Midway City Council  
13 June 2018  
Regular Meeting

Whitaker Farm /  
Preliminary Approval

## **CITY COUNCIL MEETING STAFF REPORT**

**Subject: Whitaker Farm Subdivision – Master Plan Review**

# WHITAKER FARMS SUBDIVISION PRELIMINARY PLAT

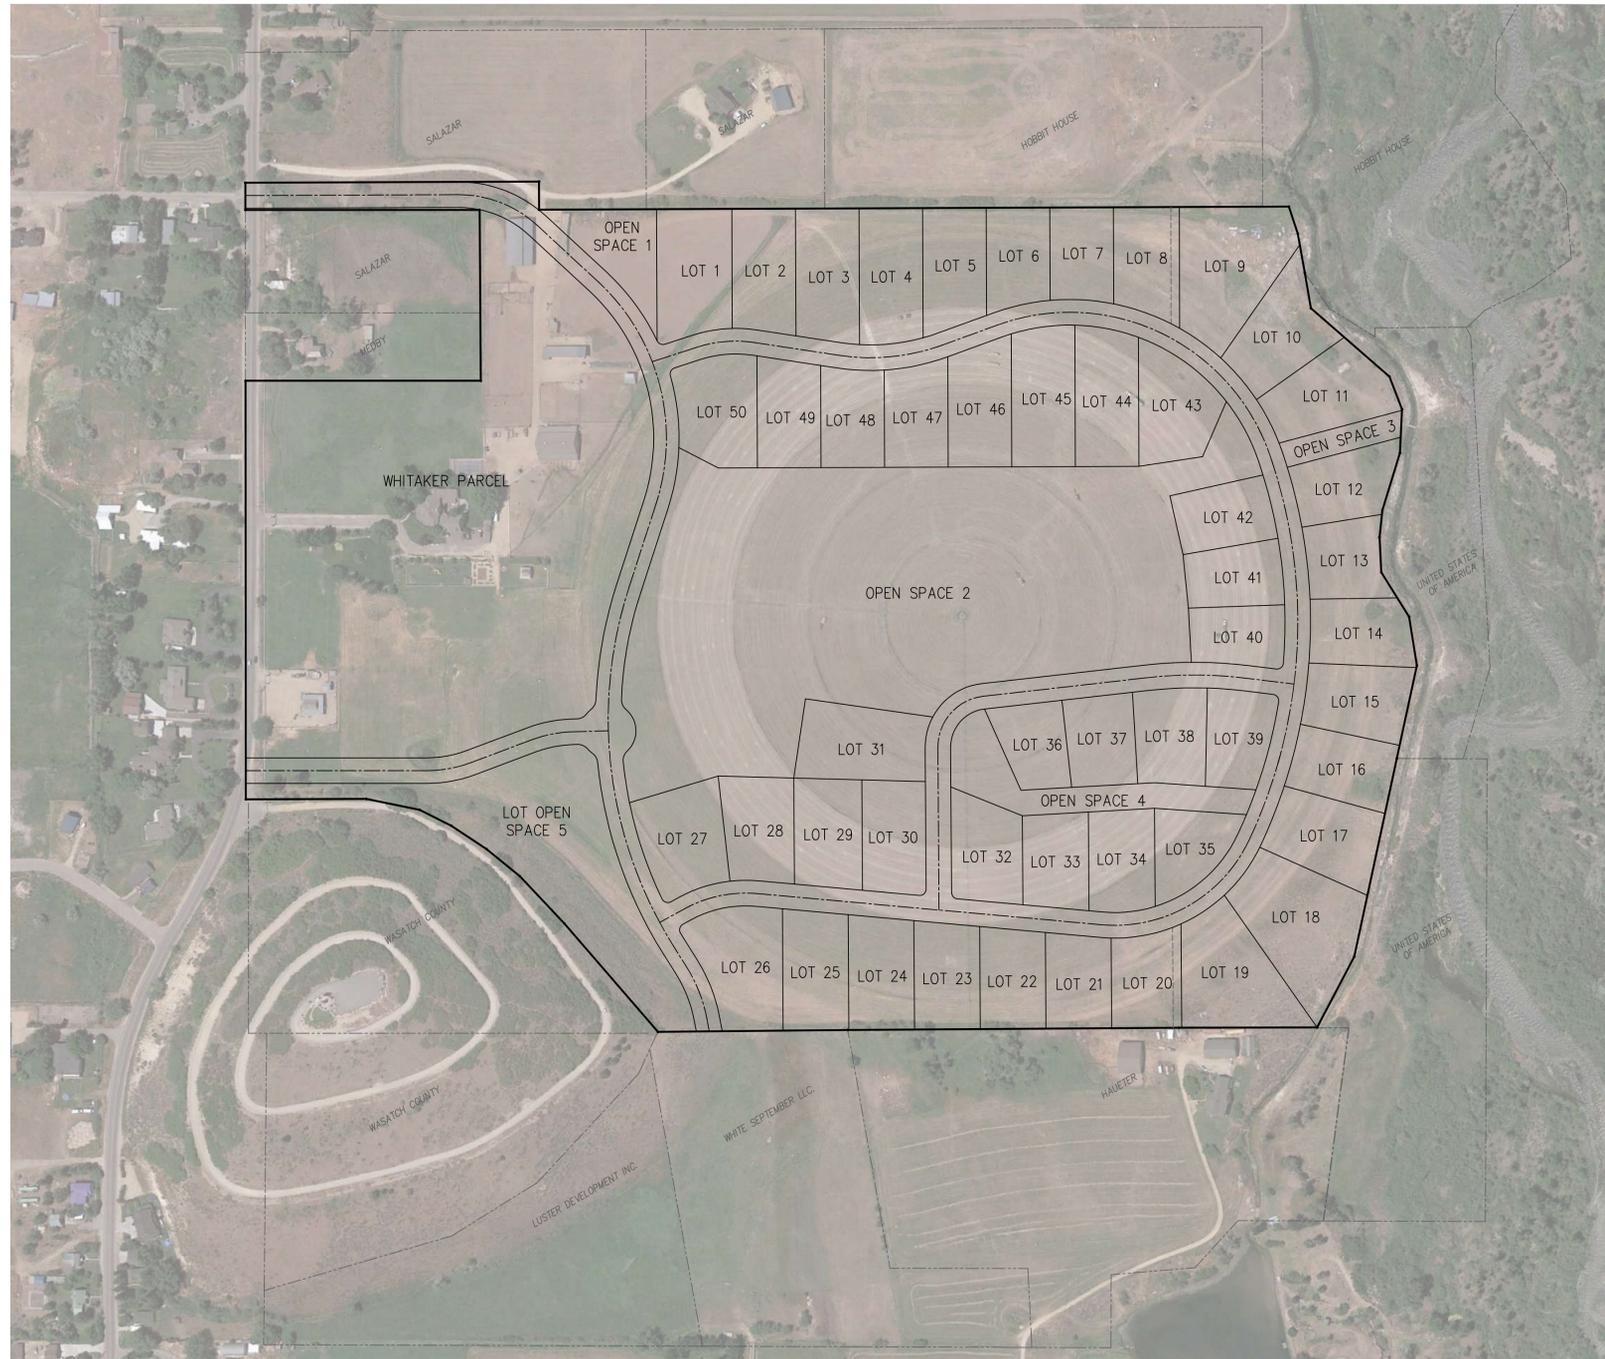
- All existing features need to be shown on plans such as existing asphalt, fences, ditches, buildings, houses, barns, etc. and details indicating what will be preserved or removed.
- The roads, culinary water, pressurized irrigation system, and storm drain systems within this development will be public infrastructure and maintained by Midway City.
- Each phase within the Master Plan is a stand-alone phase.

- The proposed development will be served from the Gerber Mahogany pressure zone.
- The proposed development will connect to the existing 8" culinary water line in River Road.
- Each of the water lines within the development will be 8". The proposed culinary water system will provide fire flows.
- The current design only connects the water line to River Road at 600 North. To increase the fire flow and provide a redundant source, the development could connect to River Road within both connection roads and provide a looped system.

- The proposed roads within development will have right-of-way widths of 56'. The rural cross-section using a ribbon curb and an 8' trail on one side will be used.
- Design for access to the Memorial Hill road and parking lot off of the proposed roadways need to be addressed. The grade of the roadway onto the Memorial Hill road will need to be shown.

- It is proposed that a trail system will be installed throughout the subdivision. The proposed trail system will connect to Memorial Hill and continuing to the south property line.
- Trail cross sections and connectivity should be discussed.

- No storm drain plans were submitted with this master plan. The storm water within the proposed development will need to be collected and retained onsite. Storm drain plans and runoff calculations will need to be submitted for the preliminary review.

- Roadway cross sections
- Proposed design for River Road improvements including cross section and center turn lane. Along with proposed asphalt and cut/fill slope lines showing the widening limits of River Road.
- Memorial Hill parking lot design
- Geotechnical report
- Storm Drain plans and runoff calculations
- Pressurized Irrigation Plan
